SAFETY RECALL AND UPGRADE NOTIFICATION TO END-USERS OF RAILOK VERTICAL RAIL SAFETY SYSTEMS IMMEDIATE ACTION REQUIRED

DBI-SALA RAILOK VERTICAL RAIL SAFETY SYSTEM

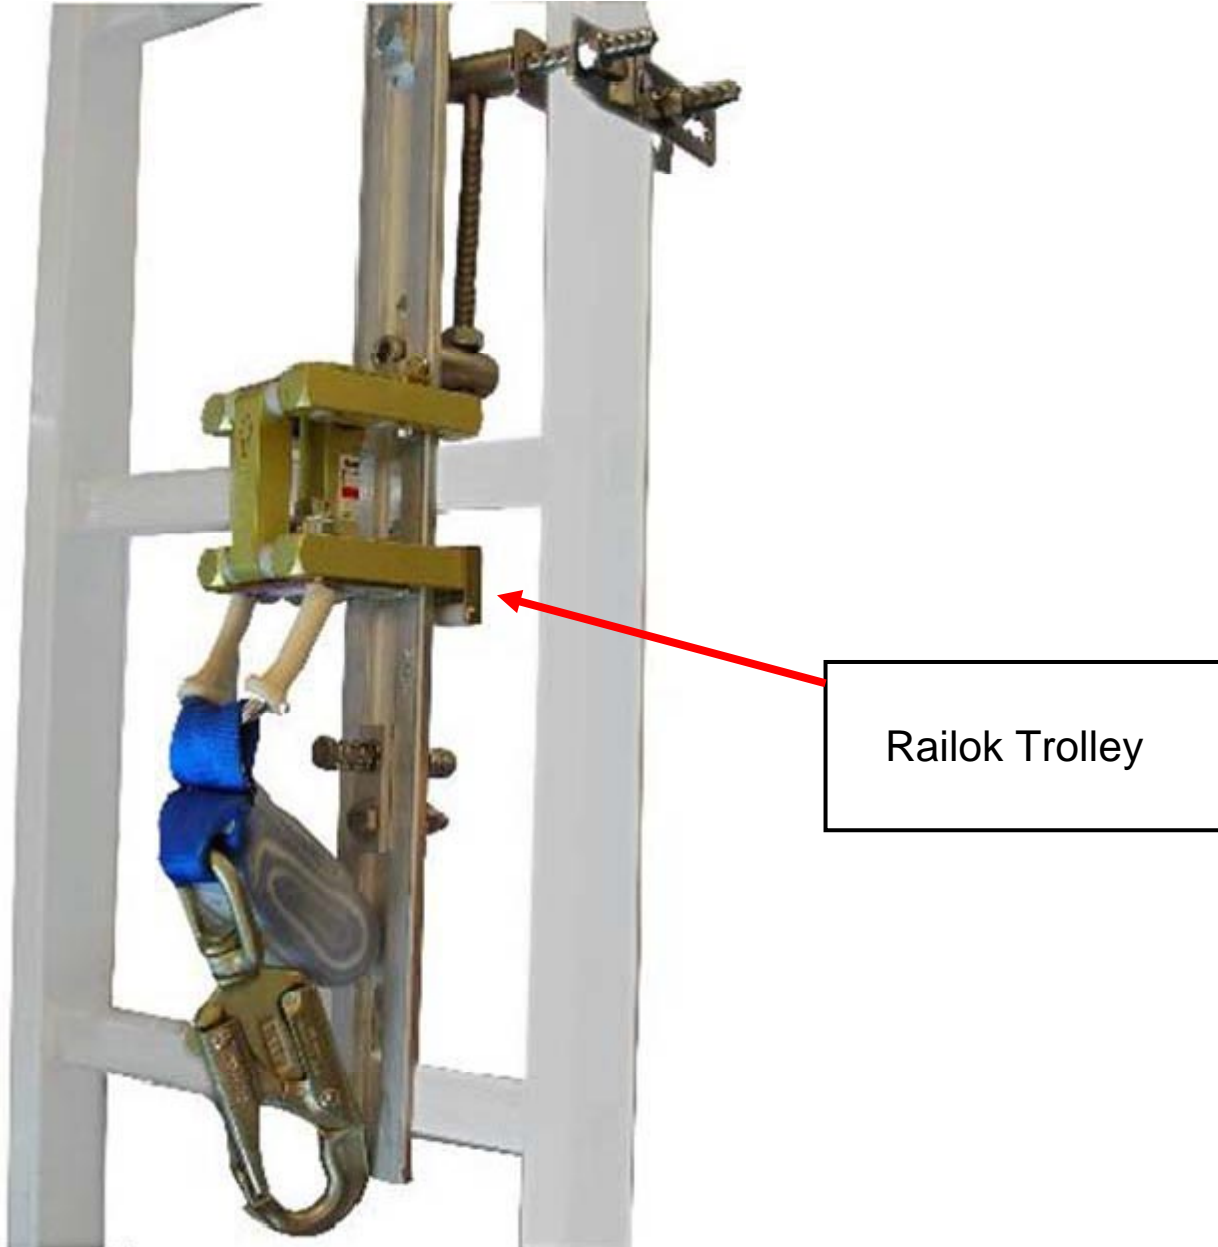
Capital Safety Group Ltd (“Capital Safety”) is undertaking a voluntary safety recall of the trolley component of the DBI-SALA Railok Vertical Rail Safety System (“Railok System”). The Railok System is a fixed rail system comprising a trolley, rail, and attachment devices – see attached photograph of the Railok System and trolley component.

The reason for the recall is the possibility that, under the latest set of tests designed to simulate a worker falling backwards, if a worker falls backwards before falling downwards (a scenario not contemplated by the dynamic test underlying the current standard), the trolley may not engage the rail as intended, and the worker may sustain serious injury. Earlier this year, the British Standards Institution recommended that new tests be included in an amendment to EN353-1:2002 that better represent all possible fall scenarios. Even though such new test procedures have not been incorporated into EN353-1:2002, Capital Safety has responded by developing an upgraded trolley as part of our continuing commitment to product improvements and state-of-the-art safety solutions. The upgraded trolley meets or exceeds proposed benchmark test requirements and thereby far exceeds the performance requirements of the current EN353-1:2002 standard.

If you have a Railok trolley in service, you should immediately take the trolley out of service and call our Customer Service department at +44(0) 1928 571 324 to arrange to return your trolley and be provided with an upgraded trolley at Capital Safety’s expense. The free upgrade applies only if the returned trolley is in proper working condition as determined by Capital Safety; if not, charges may apply.

Pending installation of the upgraded trolley, end-users must use alternative fall arrest systems (e.g., twin lanyard). This Notice relates to all Railok trolleys supplied by Capital Safety or its distributors at any time in the past.
